URGENT Field Safety Notice

ABL90 FLEX and ABL90 FLEX PLUS

– Risk of incorrect time and potentially biased results

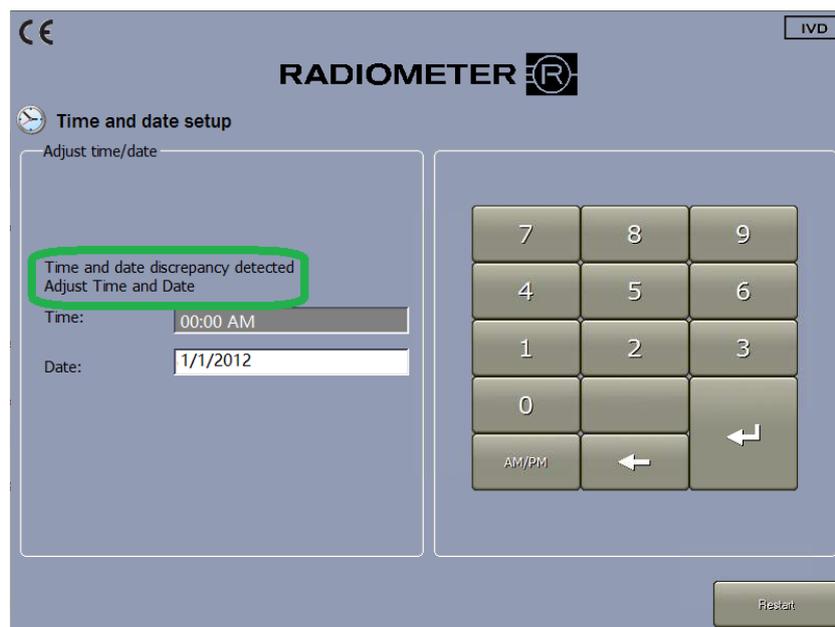
The software update ensures that the analyzer will detect any date and time discrepancy that may appear during a startup following an abrupt power break.

When detected the analyzer will:

- Reset the date to 1/1/2012 and time to 00:00 (or earlier) and start running from there.
- Display the following screen prompt prior to full startup:

*Time and date discrepancy detected
Adjust Time and Date*

- The operator must then adjust time and date and touch Restart to confirm and restart the analyzer.

If the analyzer shows the above screen during startup then adjust the time and date.
